# **KEYSTONE ELECTRONICS CORP.**

NYLON M/F HEX STANDOFF

4803

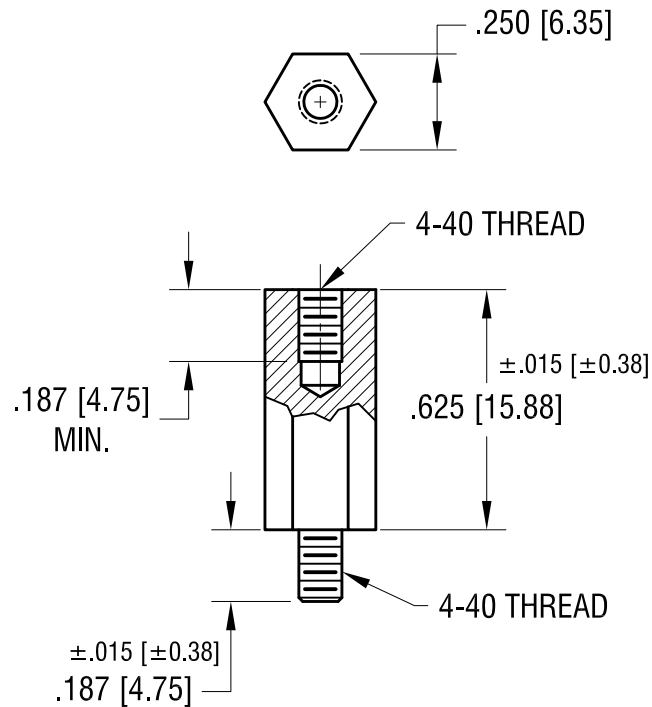
6.26.23 (A1) WAS  $.187 \pm .015$   
CHANGE AS PER ECN 23-105
